## SERVICE BULLETIN AMATEUR RADIO

SUBJECT TS-940S SSB TALK POWER IMPROVEMENT	DATE 7/22/87
---	-----------------

FIGURE 1

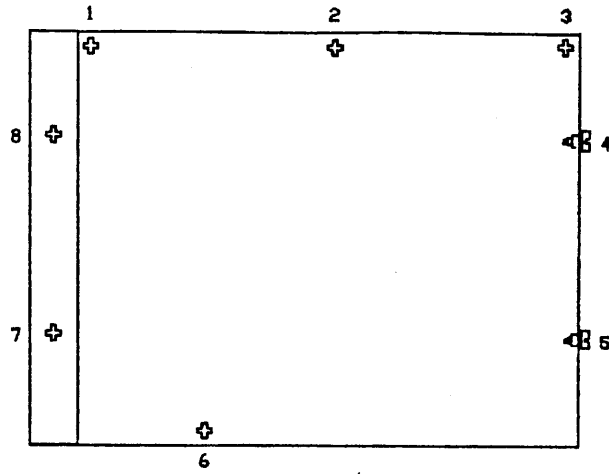
4. Locate transistor Q37 on the board (toward the back right hand side). The two capacitors are mounted on the foil side of the board underneath Q37.
5. To access the bottom of the board remove the 8 screws that mount the board and heat sink to the chassis (See figure 1).

FIGURE 2

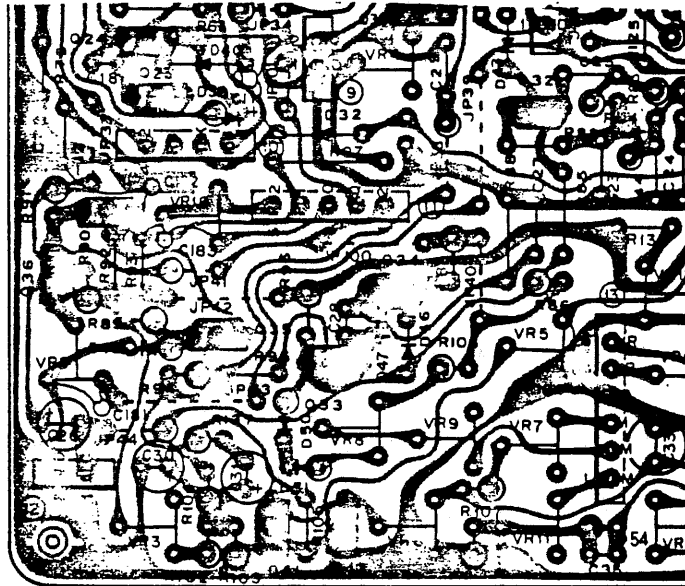
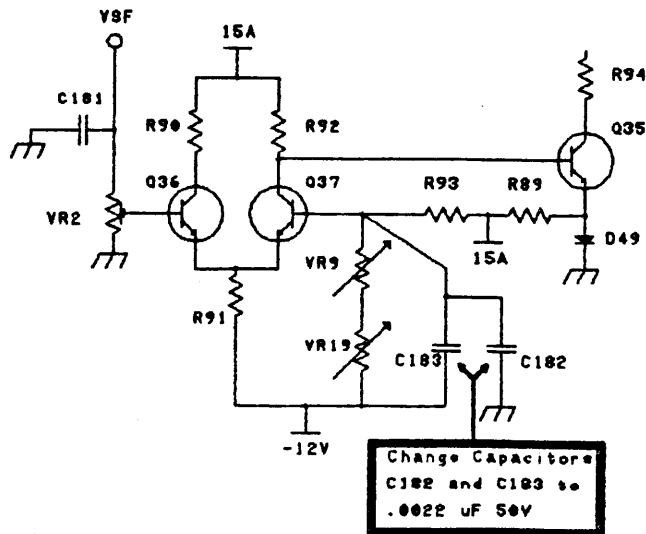
TS-940S in the serial number range of 601xxxx through 708xxxx may be limited in SSB peak power as compared to full CW output. The level may be increased by changing the value of capacitors C182 and C183 in the ALC circuit on the Control board. The recommended replacement value for each capacitor is 0.0022 uF, 50V (PART # CK45B1H222K).

6. Carefully lift the board/heat sink from the right hand side and pivot it toward the front of the transceiver.
7. Replace C182 and C183 with 0.0022 uF, 50V capacitors (see figure 2 for PC board view).
